**SITE AND ARCHITECTURAL REVIEW COMMITTEE
TUESDAY, SEPTEMBER 27, 2016
6:45 p.m.**

MEMORANDUM

To: Site and Architectural Review Committee **Date:** September 27, 2016
From: Cindy McCormick, Senior Planner
Via: Paul Kermoyan, Community Development Director *PK*
Subject: New office building - 95 E. Hamilton Ave *Com*
File No.: Site & Architectural Review Permit (PLN2015-74)

TREE REMOVAL & PLANTING PLAN
1/8" = 1'-0" 1

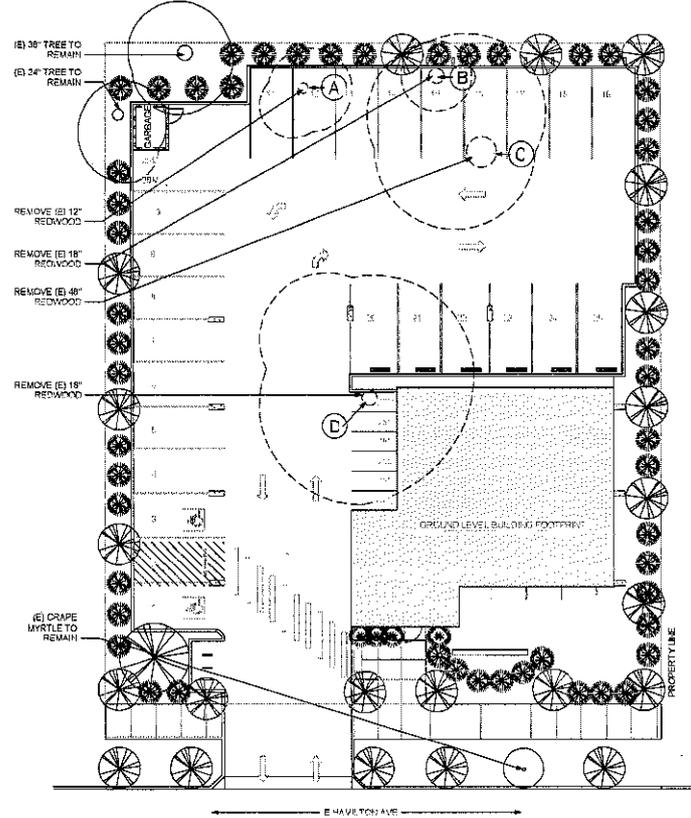
Tree Removal: The application requires a Tree Removal Permit to remove four protected Redwood trees. One of the trees, a very large Redwood in the middle of the property, would likely cause significant damage to the proposed building that cannot be controlled or remedied through reasonable modification of the tree's root or branch structure. The other three trees are located towards the rear of the lot where the new parking lot is proposed (reference page A104 of **Attachment 2**). Retention of these trees would restrict the economic enjoyment of the property by severely limiting the use of the property in a manner not typically experienced by owners of similarly zoned and situated properties. While a minor reduction in the building size would not represent a severe limit of the economic enjoyment of the property, the building would likely need to be made significantly smaller to reduce the required parking spaces enough to preserve the trees. Alternatively, the parking would need to be built underground, at considerable expense to the applicant. However, the required parking spaces could be reduced to help preserve the one or more trees at the rear of the lot, as was done for the previously approved project.

The SARC should determine if removal of all four trees is warranted due to an undue hardship (economic enjoyment of the property), or if the project should be redesigned, or the parking reduced, to save one or more trees. The previously approved project was allowed to reduce the number of required parking spaces (from 22 spaces to 19 spaces) in order to preserve trees.

A109

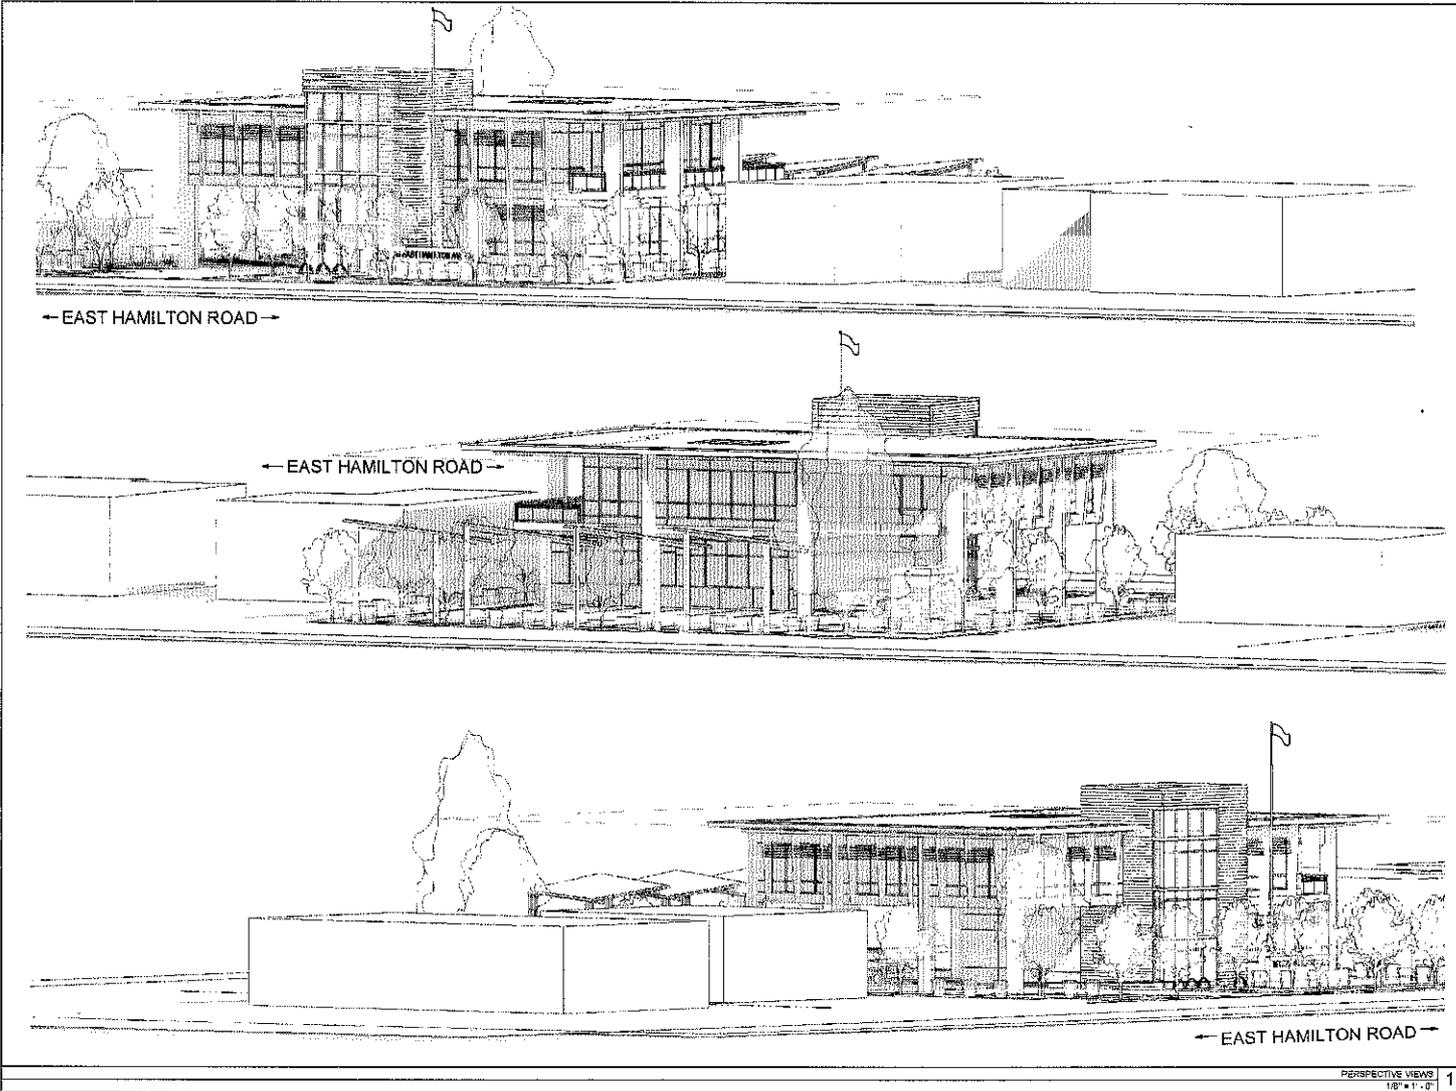
Building Design: The proposed project consists of a two-story office building. The modern design incorporates quality building materials including dark brown metal siding, beige limestone tiles, grey cement panels, and white plaster (reference page A107 of **Attachment 2**). The design also includes a large amount of glazing accented by blackened steel mullions. A portion of the second story is designed as a podium over the parking lot entrance while the right side of the building features a large upper story deck, created by setting back the second story. The design of the second story helps reduce the massing of the building while retaining the desired floor area and necessary site circulation and parking.
